Form 3160-5
(June 2019)UNITED STATES
DEPARTMENT OF THE INTERIOR
BUREAU OF LAND MANAGEMENTFORM APPROVED
OMB No. 1004-0137
Expires: October 31, 2021**SUNDRY NOTICES AND REPORTS ON WELLS**
Do not use this form for proposals to drill or to re-enter an abandoned well. Use Form 3160-3 (APD) for such proposals.

8. Well Name and No. ICY 18 FED/502H

9. API Well No. 30-025-46689

EOG respectfully requests an amendment to our approved APD for this well to reflect the following changes:

WELL LOCATION AND ACREAGE DEDICATION PLAT

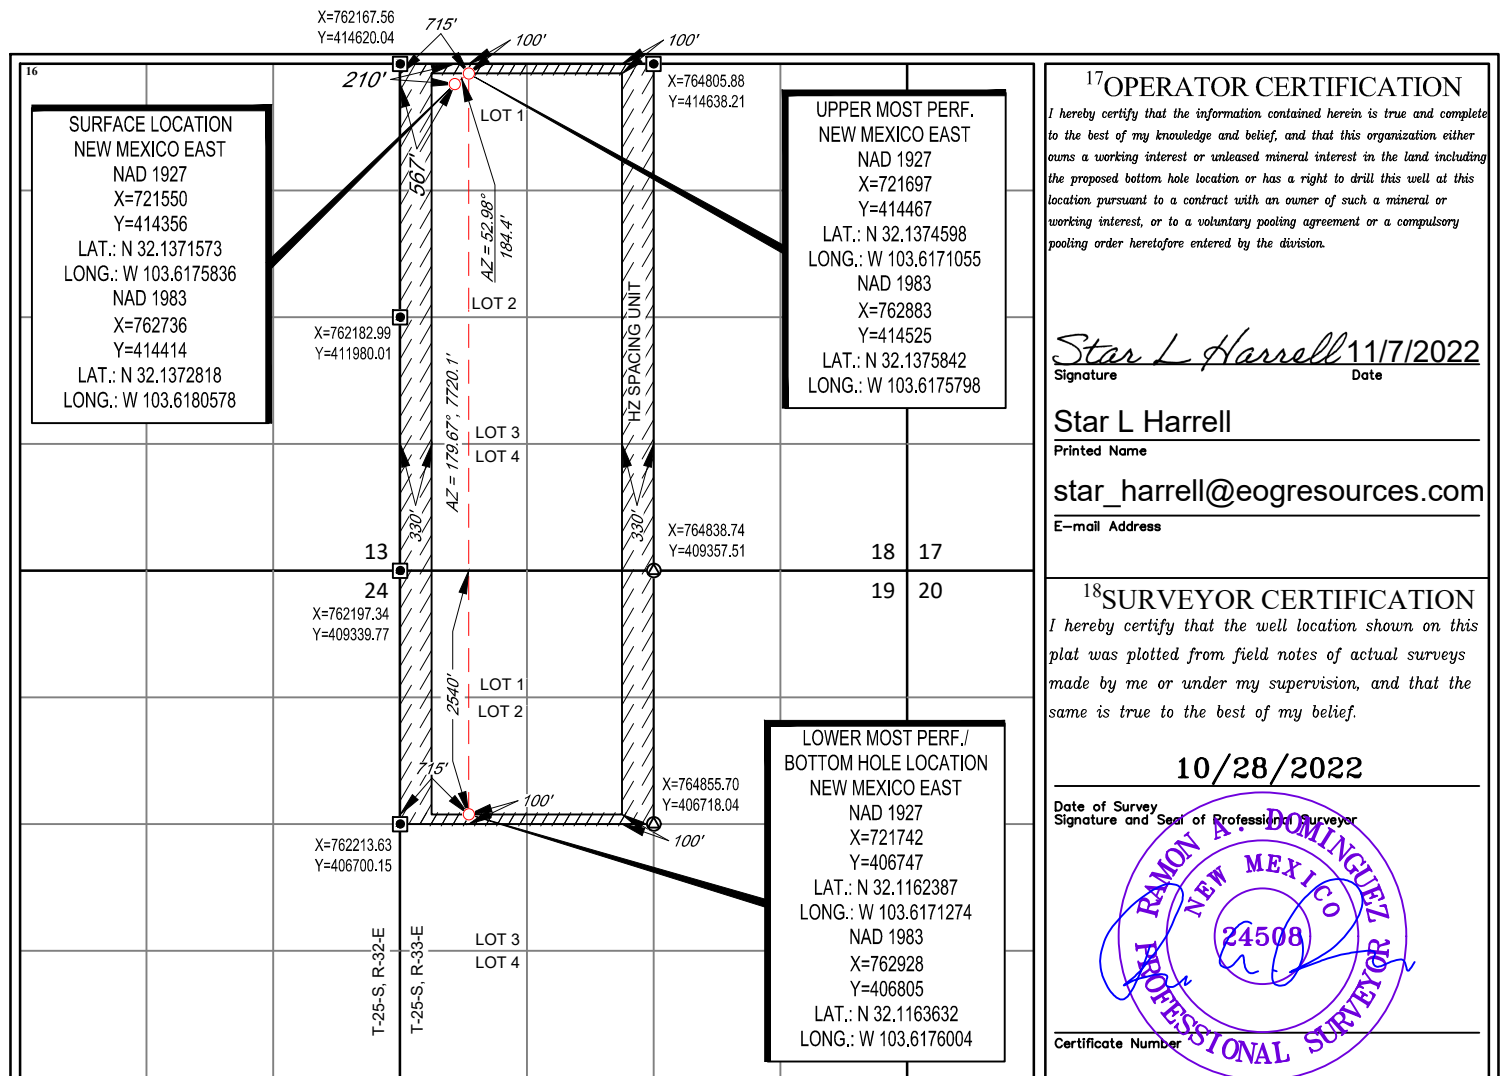
Change BHL from T-25-S, R-33-E, Sec 19, 2540' FNL, 910' FWL, Lea Co., NM,
to T-25-S, R-33-E, Sec 19, 2540' FNL, 715' FWL, Lea Co., N.M.

UL or lot no.	Section	Township	Range	Lot Idn	Feet from the	North/South line	Feet from the	East/West line	County
2	19	25-S	33-E	-	2540'	NORTH	715'	WEST	LEA
